<b>Subject:</b> <b>CHIRP / CLUNK NOISE FROM REAR SHOCK ABSORBERS</b>	<b>Bulletin No:</b> 02-003/14
	<b>Last Issued:</b> 12/30/2014

- This bulletin supersedes the previous bulletin 02-003/14, issued on 10/23/2014, 09/18/2014. The APPLICABLE MODEL(S)/VINS, DESCRIPTION, REPAIR PROCEDURE, PARTS AND WARRANTY INFORMATION have been revised.
- Changes are noted below in Red beside the change bar.

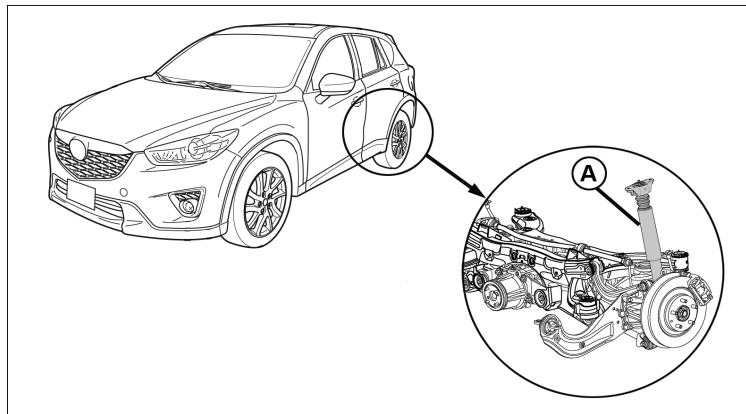
Some vehicles may exhibit a chirp/clunk type noise from the rear shock absorbers (A) when driving on a rough road or passing over a speed bump. Visual inspection of the shock absorbers show no external damage.

1. Verify customer concern.
2. Replace the rear shock absorber. Refer to MS3 online or Workshop Manual section 02-14:
  - CX-5 - REAR SHOCK ABSORBER REMOVAL/INSTALLATION
  - Mazda6 - REAR SHOCK ABSORBER REMOVAL/INSTALLATION

**NOTE:** Only replace the affected side.
